## ADDENDUM NO. 4

Reference: Ice Sheet Addition  
Weber County/WSU – Ogden, Utah  
DFCM Project No. 12265810

The Ice Sheet Addition  
4390 Harrison Blvd.  
Ogden, Utah

DFCM Project No. 12265810  
FFKR Project No. 11124

**LEVEL 1 FLOOR PLAN**

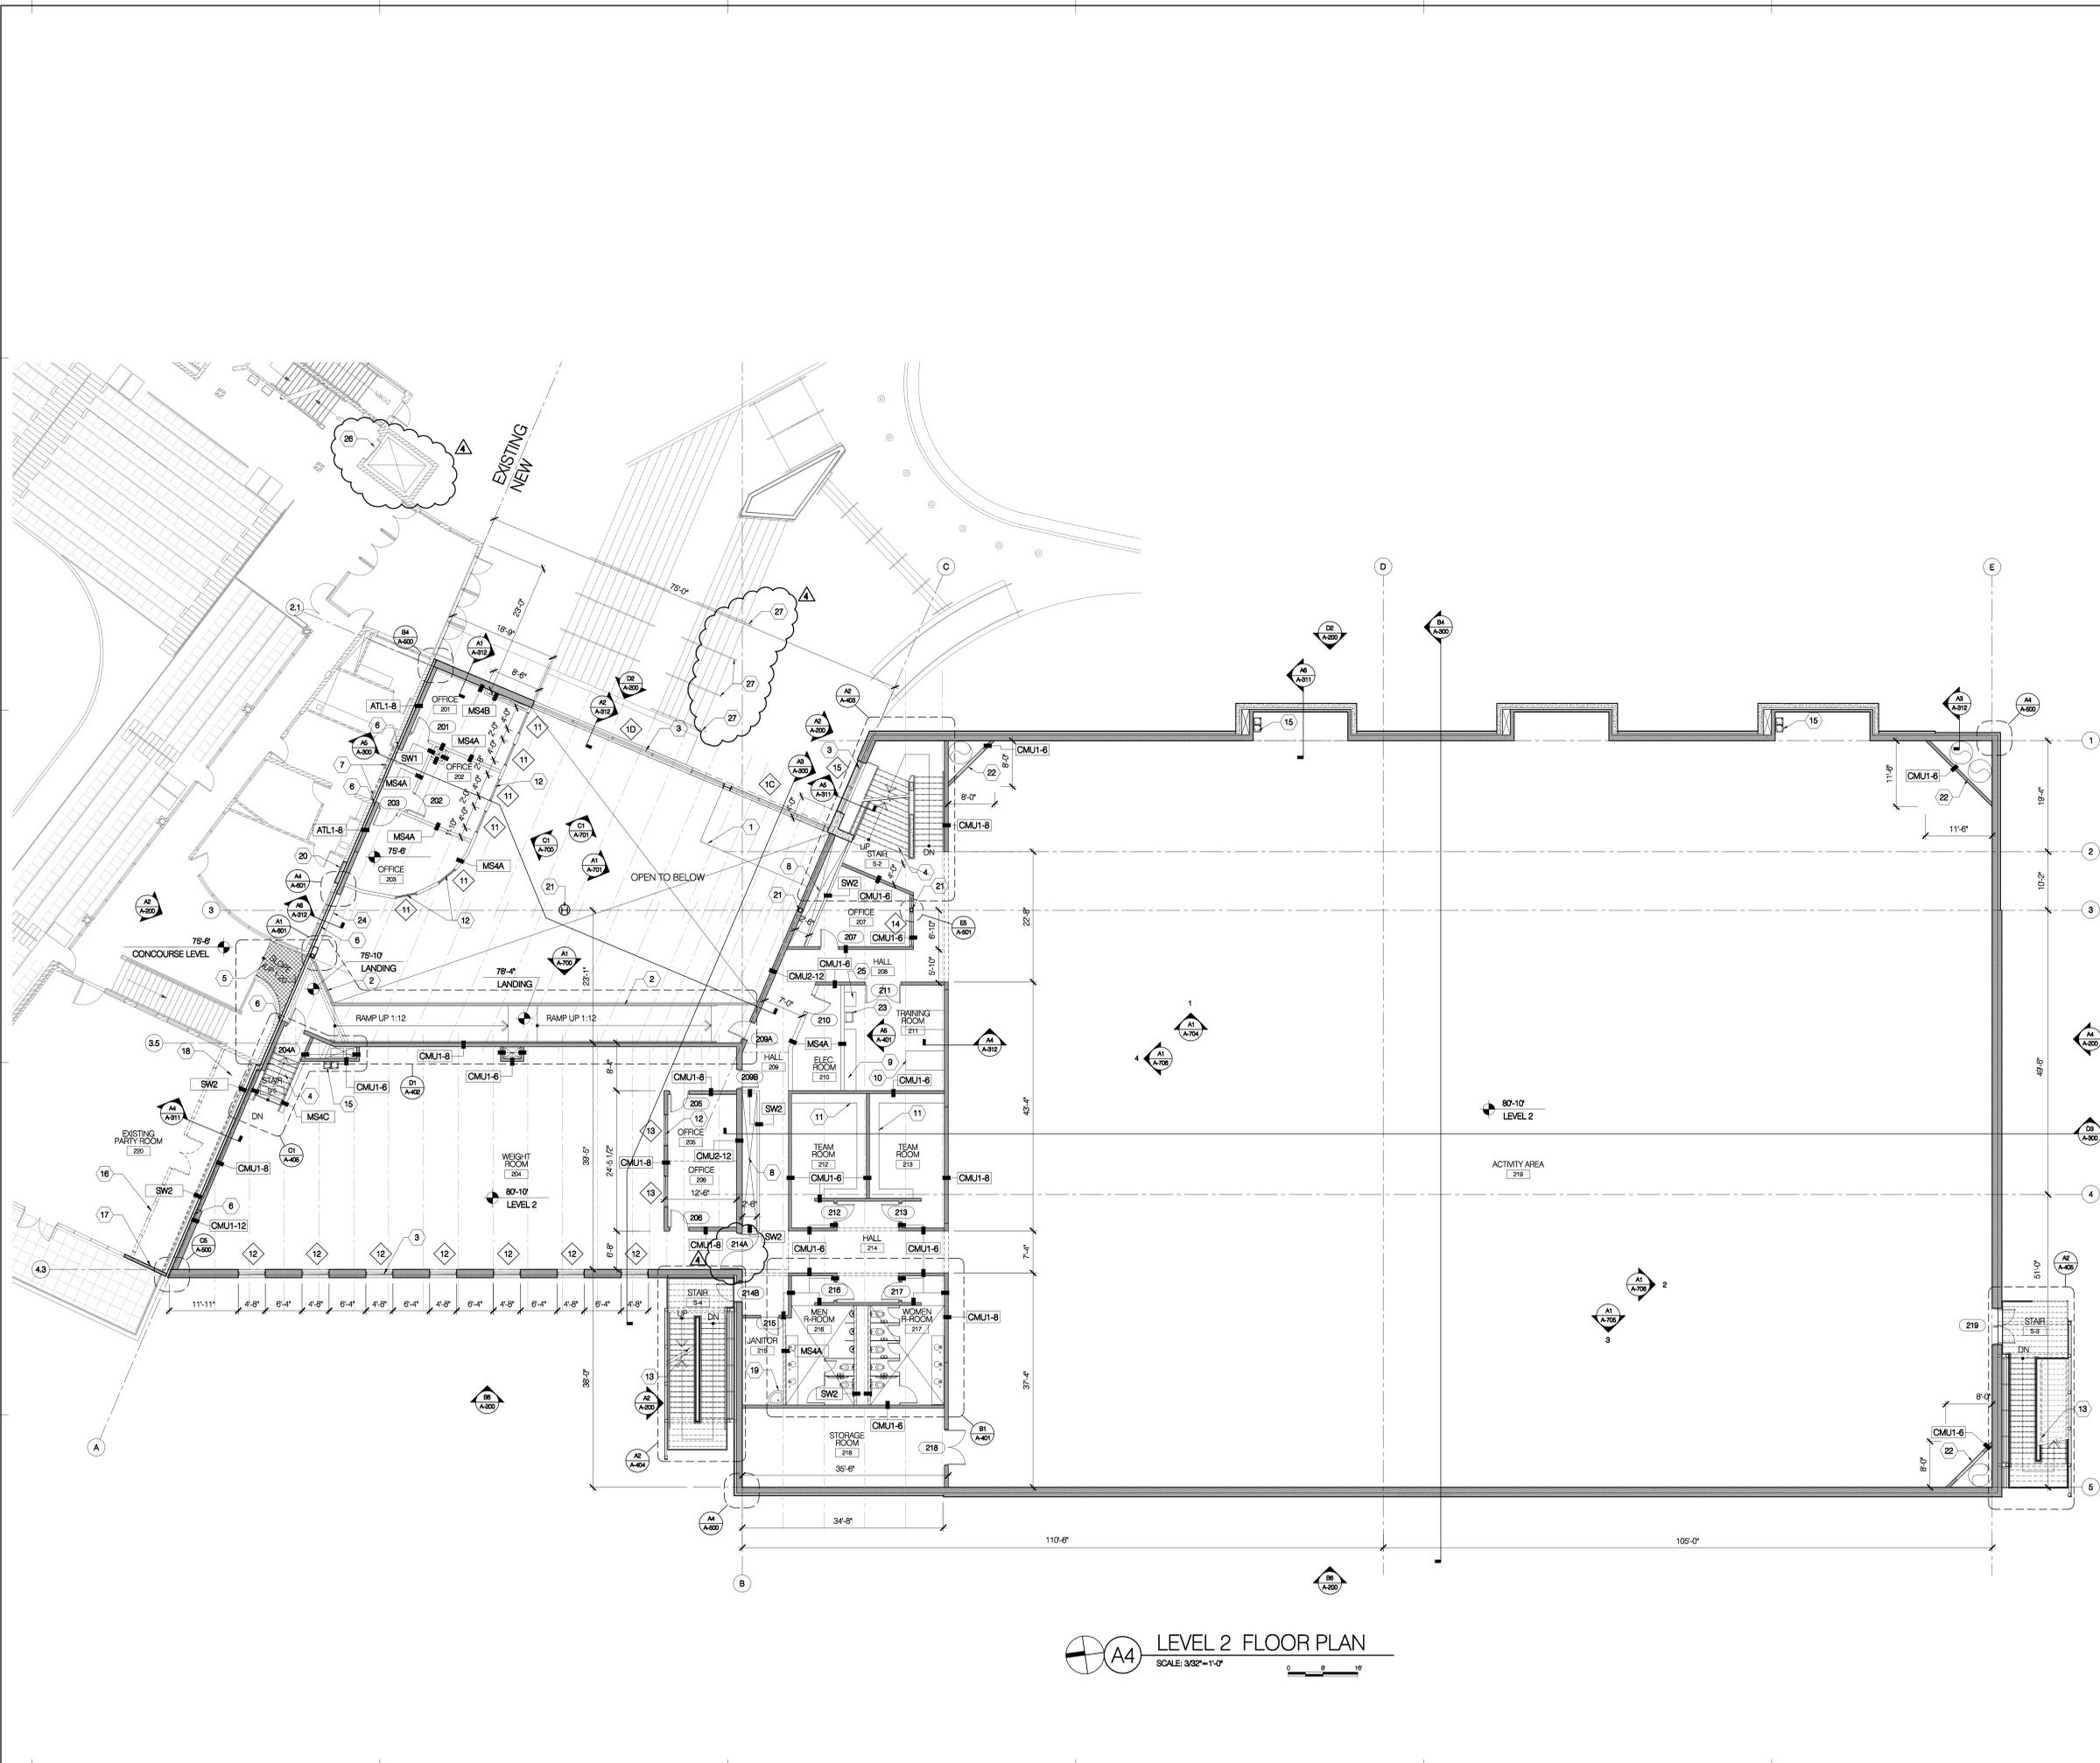
SHEET A-101 – LEVEL 1 FLOOR PLAN – Re-issued.

1. Refer to clouded modifications on re-issued sheet.

**D3 SEISMIC BRACING DETAIL**  
NOT TO SCALE

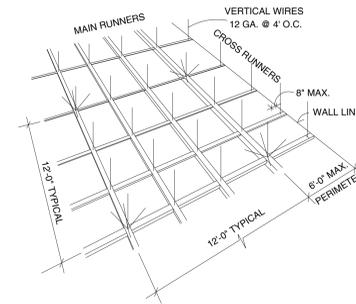
SHEET A-111 – LEVEL 1 REFLECTED CEILING PLAN – Re-issued.

1. Detail D3 – SEISMIC BRACING DETAIL; Modify detail as shown.

**A1 PARTITION TYPES**  
SCALE: 1/2" = 1'-0"

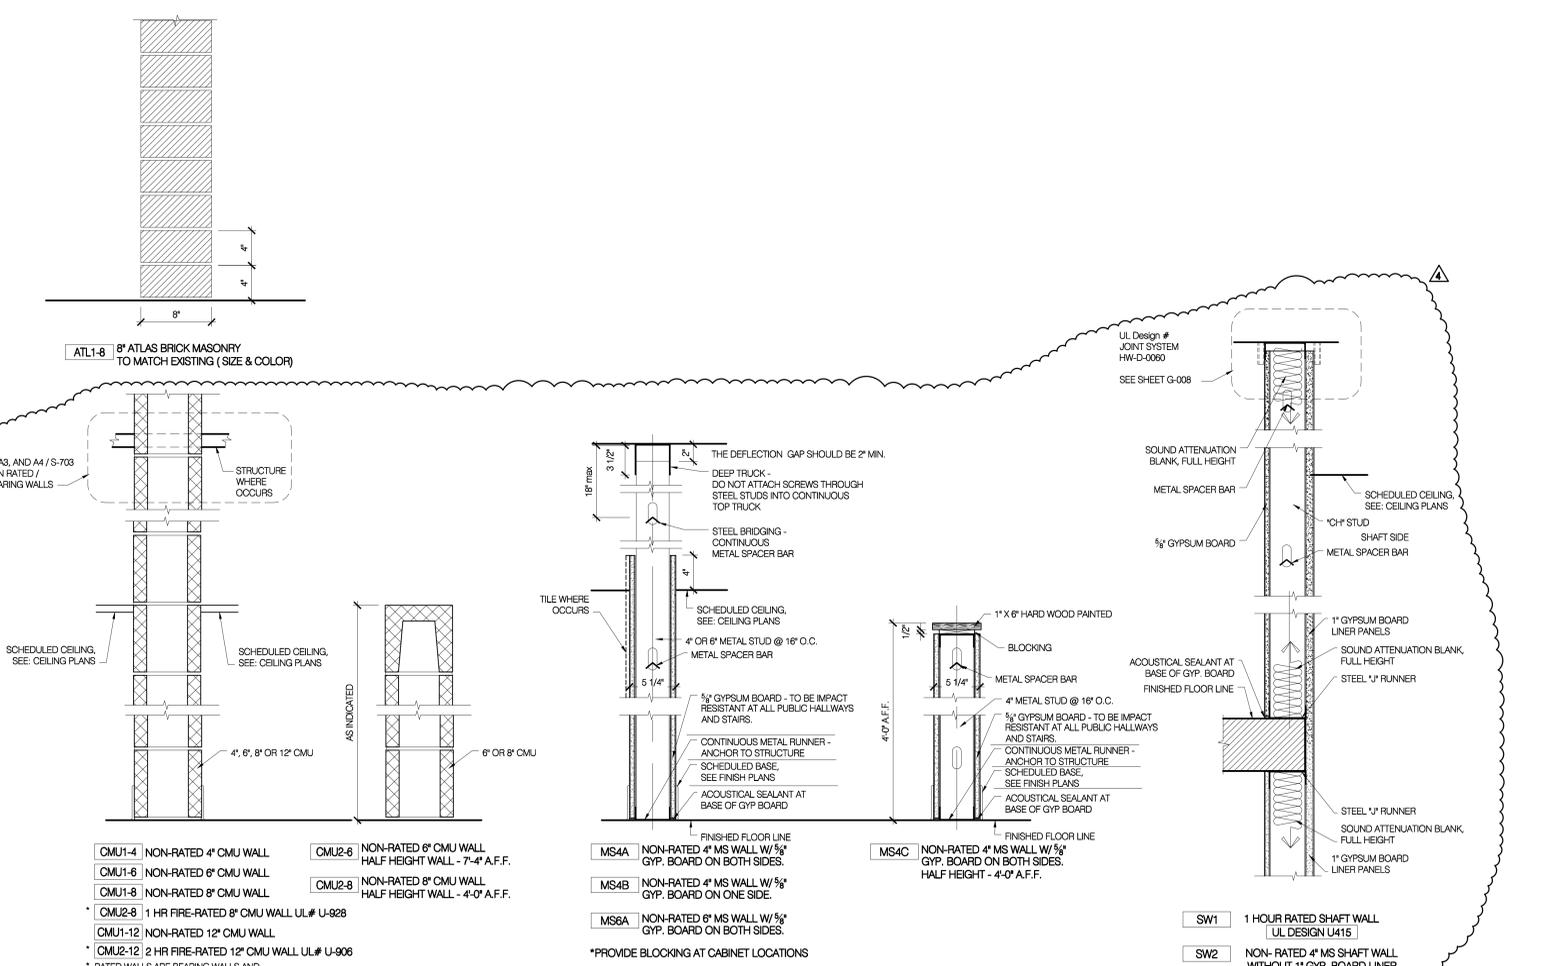
SHEET A-600 – DOOR SCHEDULE & PARTITION TYPES – Re-issued.

1. A1 – PARTITION TYPES; Refer to the clouded modifications on re-issued sheet.
2. DOOR AND FRAME SCHEDULE; Add: “Door Opening 112 Refrig. Room”.
